Service Bulletin

NO:HIFI2-01-016

SUBJECT: No playback

MODEL (S): MZ-E700, MZ-E900

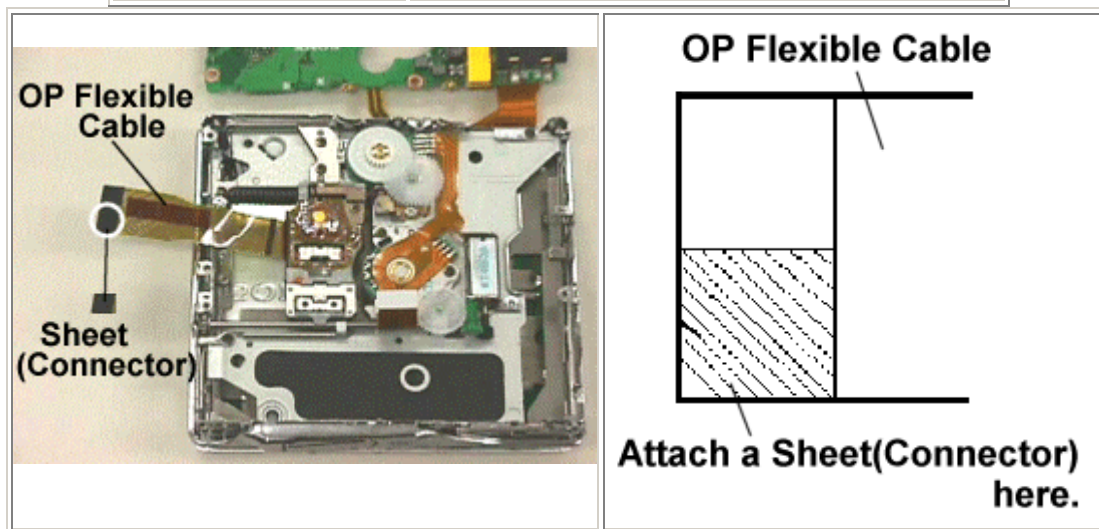
Symptom: No playback, "NO DISC" or "DISC ERR" will be displayed.

Cause: Poor contact between CN501 and OP flexible cable.

Solution: Attach a sheet (connector) on the tip of the backing side of the OP flexible cable

Description	Part Number
SHEET(CONNECTOR)	3-232-142-01
